Proposal for collective amendments to Regulations Nos. 14 and 16

The text reproduced below was prepared by the expert from the Netherlands to ban confusion that has to do with the recently broadened height requirements for the effective upper belt anchorage (Supplement 4 to the 07 series of amendments to Regulation No. 14).

Annex 1B (Communication of a type of safety-belt or restraint system ...), item 12, to read:

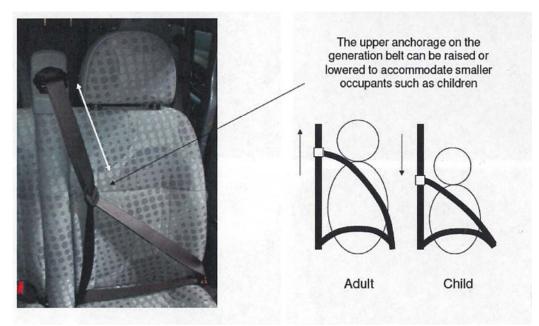
1. Up to now in Regulation No. 16, in the approval certificate, where strikethrough actions are done, only one system for "Belt adjustment for height" can be mentioned, namely upper-pillar loop.

2. Alas this proved to be the cause of confusion. Namely a belt/restraint system (later to be used for a Regulation No. 14 approval) could still be a system with height adjustment **but by means of a flexible adjustment device (sometimes called generation belt, see the explaining figure below).**
